UNITED STATES PATENT AND TRADEMARK OFFICE

APPLICATION NO.	FILING DATE	FIRST NAMED INVENTOR	ATTORNEY DOCKET NO.	CONFIRMATION NO.
10/698,864	10/31/2003	Simon J. Lewis	15581.10.1	2003

DETAILED ACTION

Figure C.

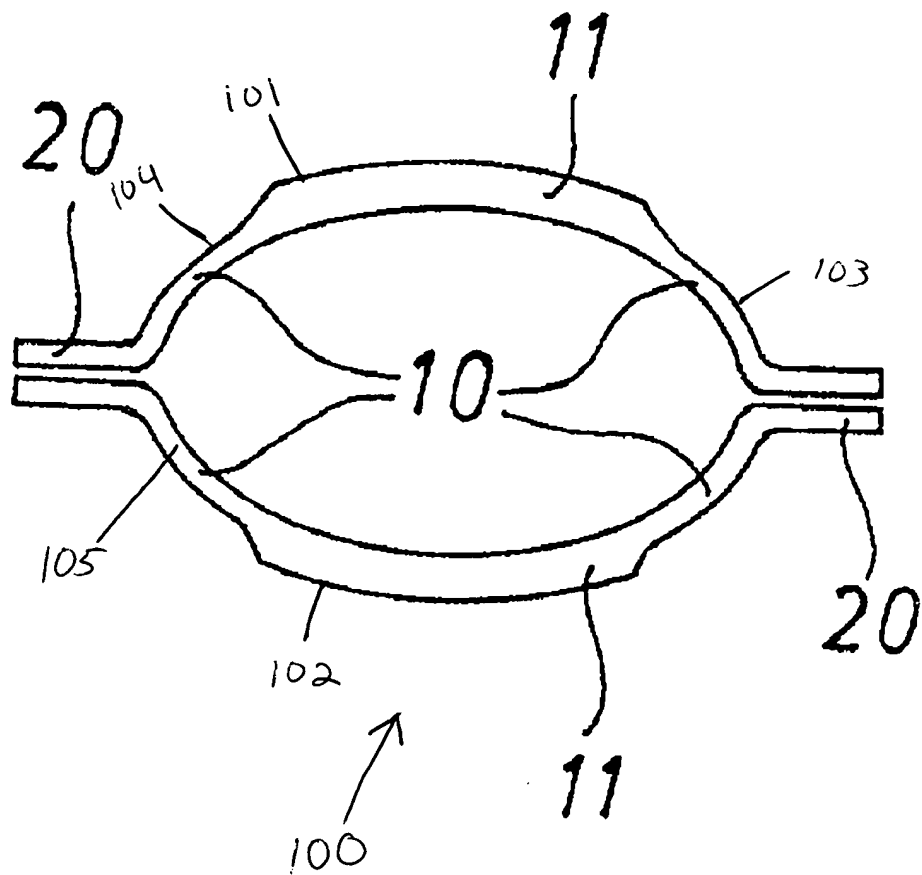
On the other hand, Klein teaches a body comprising a top wall (Figure C, #101 – See exploded view of Figure 2 from Klein (US 2002/0108428 A1), provided by Examiner at the end of this Office Action), a bottom wall (102), and a pair of opposing side walls (103, 104) extending therebetween, the top wall (101) and bottom wall (102) having a substantially flat exterior surface extending along the length thereof; and the top wall (101) having a thickness (11) and each of the side walls having a thickness (105), the

thickness (11) of the top wall (101) being greater than the thickness (105) of at least one of the side walls (104).

With respect to Claim 34, Klein teaches where at least one of the sidewalls (Figure C, #103) has an outwardly bowed exterior surface extending along the length thereof.
